DR-25-04/LLA-25-02

Public Comments Received
July 31, 2026 to August 5, 2026

RE: City File No. DR-25-04 / LLA-25-02 Request to Include This Testimony in the Public Record

Figure 1: Excerpt of Site Plan – Left-turn movements from Tannler Drive into the driveway should be evaluated in conjunction with adjacent parking and backing maneuvers.

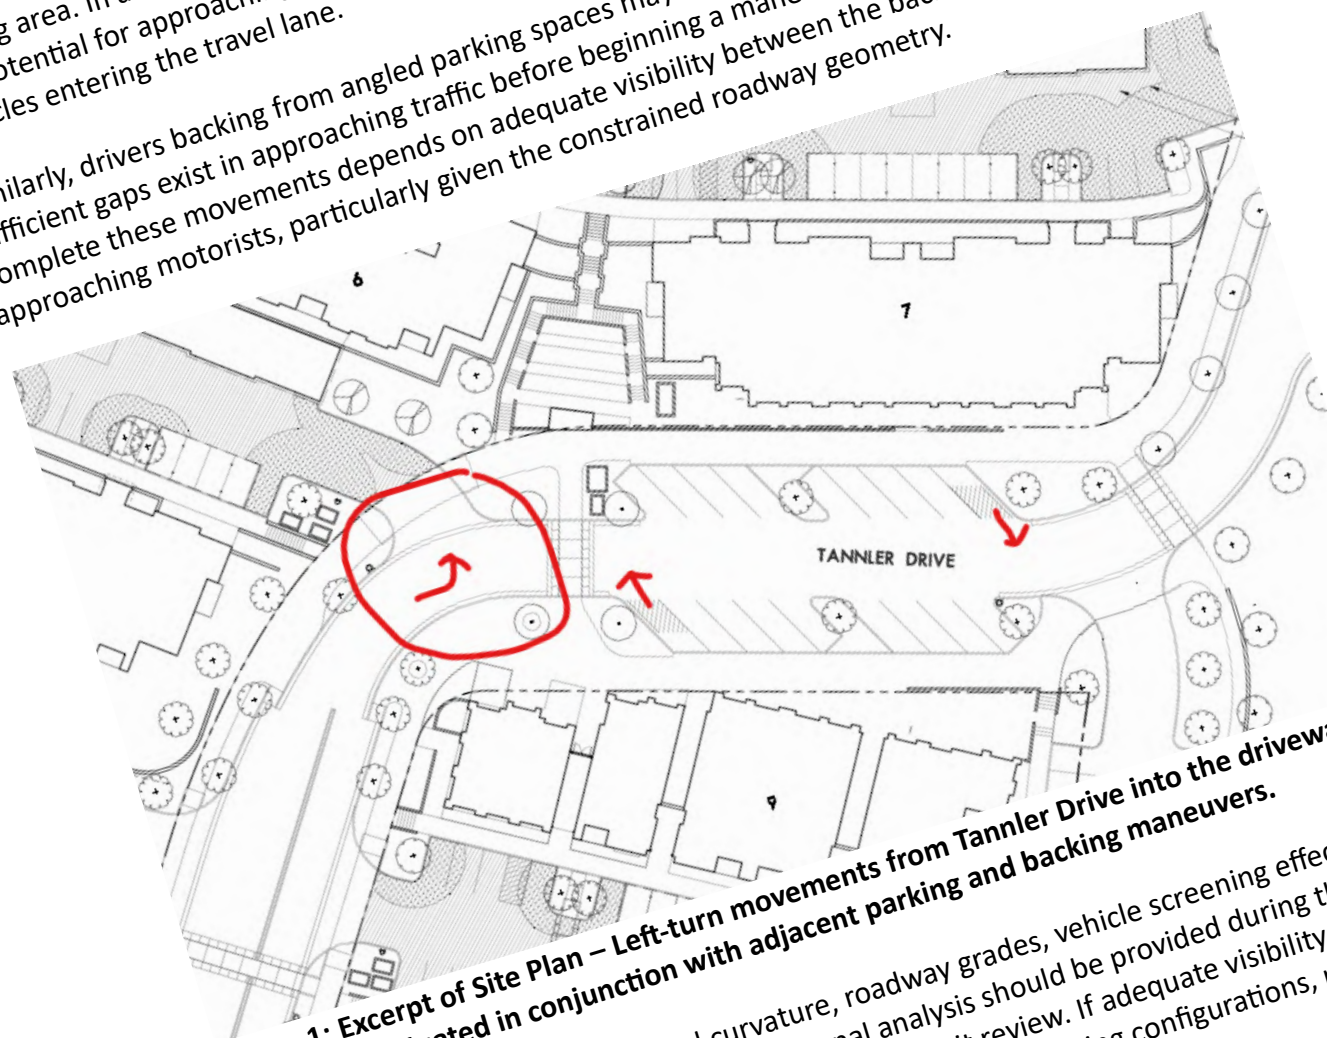
The proposed parking area is located between horizontal curves on Tannler Drive and is also affected by roadway grade changes. This combination of horizontal and vertical curvature may limit visibility for both drivers backing from parking spaces and motorists approaching the parking area. In addition, adjacent parked vehicles may further restrict sight lines. This creates the potential for approaching motorists to have limited opportunity to detect and react to vehicles entering the travel lane.

Similarly, drivers backing from angled parking spaces may have difficulty determining whether sufficient gaps exist in approaching traffic before beginning a maneuver. The ability to safely complete these movements depends on adequate visibility between the backing vehicle and approaching motorists, particularly given the constrained roadway geometry.

Given the combination of horizontal curvature, roadway grades, vehicle screening effects, and backing movements into a travel lane, additional analysis should be provided during the land use review process rather than addressed during permit review. If adequate visibility cannot be demonstrated, consideration should be given to alternative parking configurations, relocation of

Figure 3: Tannler Drive Improvements on north end of project illustrating multiuse path on west side of Tannler Drive.

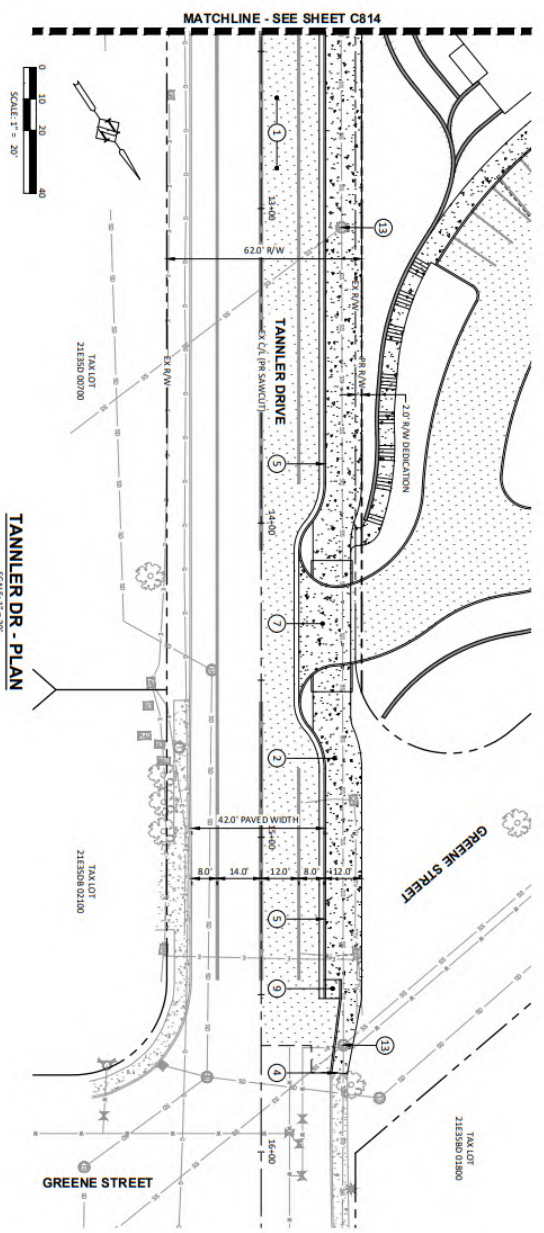
The proposed development includes a multi-use path along the north and east side of the proposed development along Tannler Drive intended to accommodate bicycle and pedestrian travel. However, the TIA does not provide a complete analysis of how users will safely transition between facilities or navigate crossings along Tannler Drive to the north of the site.

The applicant should be required to demonstrate how the proposed facility integrates with the existing bicycle and pedestrian facilities north of the project and how users are expected to transition between facilities in a safe and intuitive manner that will not result in wrong way travel or crossing Tannler Drive at unsafe locations.
